UNITED STATES PATENT AND TRADEMARK OFFICE

Office Action Summary

10/024,784

DETAILED ACTION

Figure 2 - U.S. Patent 5,866,265 to Reilly et al.

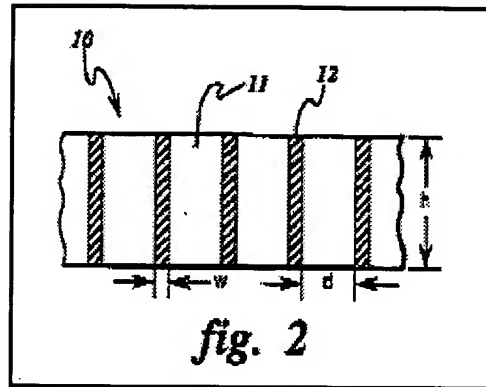
4. As per claims 1, and 3, Reilly et al. disclose a method of manufacture wherein material strips having different properties (column 3, lines 5-9; 48-59) are extruded to form regions of a grid structure (Fig. 2, above). Reilly et al. do not explicitly disclose the step of a) allowing at least one of the extruded material strips to expand in at least one direction such that at least one dimension of the extruded material strips prior to extrusion is restored or b) utilizing material strips having different X-ray transmissivities, wherein the regions alternate between materials having high X-ray transmissivity and materials having low X-ray transmissivity.

5. Reilly et al. teach a step involving the expansion of extruded material strips in at least one direction. Additionally, Reilly et al. suggest as in Fig. 2 above, that the process also include the step of allowing at least one dimension of the extruded material strips prior to extrusion be restored (see "cut" step). By way of example, Reilly et al. teach that such operation results in an ability to successfully duplicate the multiplication process, thereby enabling the construction of several patterned layers to achieve an intended thickness, density or material characteristic (see abstract; column 1, lines 1-31).

10. **As per claim 2**, Reilly et al. as modified above, disclose a method of manufacture wherein material strips are co-extruded (Reilly et al. Fig. 2, above).

11. **As per claim 7**, Reilly et al. as modified above, disclose a method of manufacture wherein material strips travel in opposite directions (Reilly et al. Fig. 2, above).

12. **As per claim 4**, Reilly et al. as modified disclose a method wherein two different material strips are fed into the entrance of a device for multiplying material strips, said material strips being divided a number of times during their travel through the device and being arranged in layers, thus forming an assembly of alternating material strips (see Reilly et al. Fig. 2 above; column 3, lines 5-17).

Figure 2 - U.S. Patent 5,581,592 to Zarnoch et al.

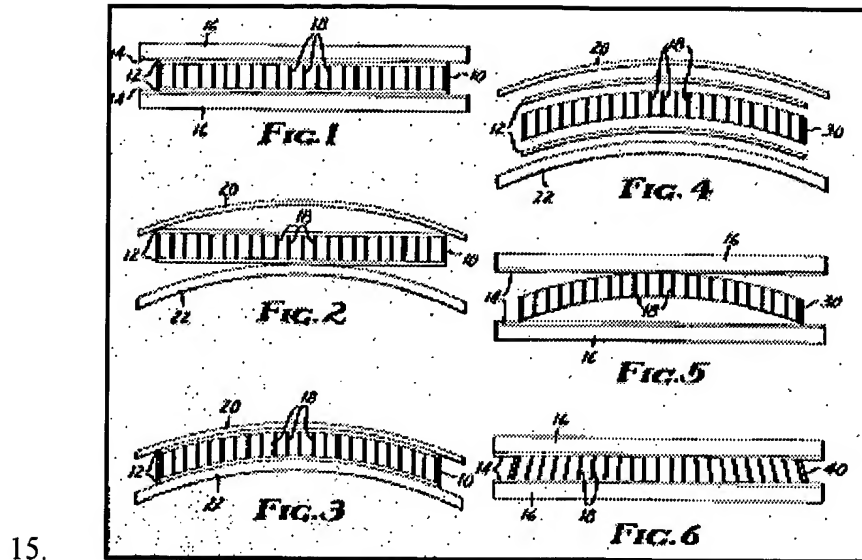
7. Zarnoch et al. disclose the grid structure (10) with successive regions having different X-ray absorption coefficients, the material strips (11, 12) having different X-ray absorbing behavior (abstract, column 3, lines 61-64). The successive regions within the grid structure result in regions that alternate between materials having high X-ray transmissivity and materials having low X-ray transmissivity (Fig. 2). Zarnoch et al. teach that such construction results in a structure that is effective in reducing X-ray radiation scatter, thereby producing high contrast images when utilized in an X-ray imaging system (see column 1, lines 29-43).

would have been obvious to further modify the method of Reilly et al. such that it incorporated the use of material strips having different X-ray transmissivities, wherein the regions alternate between materials having high X-ray transmissivity and materials having low X-ray transmissivity and used within an X-ray apparatus. One would have been motivated to make such a modification so that a grid structure, employed in an imaging system, is able to reduce scattered radiation by absorbing transmitted rays, thereby producing high contrast images as taught by Zarnoch et al. (column 3, lines 45-54; column 4, lines 60-63).

Figure 1 - U.S. Patent 5,581,592 to Zarnoch et al.

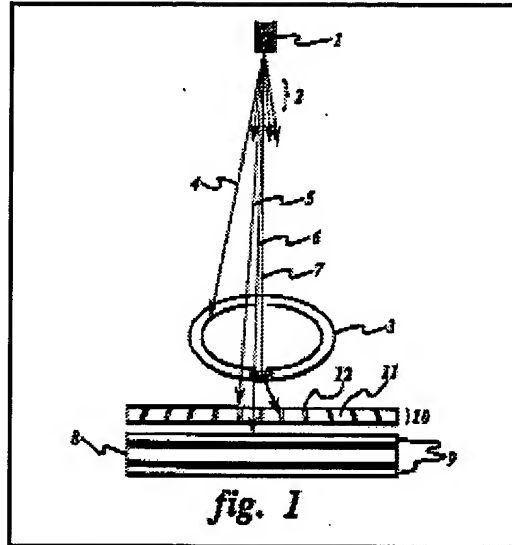
21. As per claim 6, Zarnoch et al. disclose an examination apparatus for irradiating an object (3) by means of X-rays (4); the apparatus comprising an X-ray source (1) an X-ray detector (8) a receiving space for the object (3) and an X-ray scatter grid (10) - the X-ray scatter grid structure comprising regions alternating with materials having high X-ray transmissivity and materials having low X-ray transmissivity (see Fig. 1 above, 11, 12; abstract).
